## IN THE DRAWINGS:

## REMARKS

Fig. 14

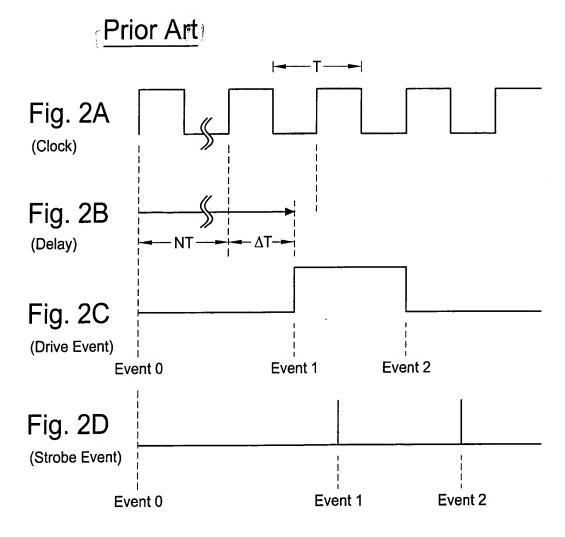
The applicant has submitted concurrently herewith a request for approval of drawing changes in which a "prior art" label is added to Figures 1 and 2A-2D to overcome the objection by the examiner and reference labels indicating registers of pipelines are added to Figures 14, 17-18, 22 and 25. The applicant has also submitted replacement sheets for the amended drawings.
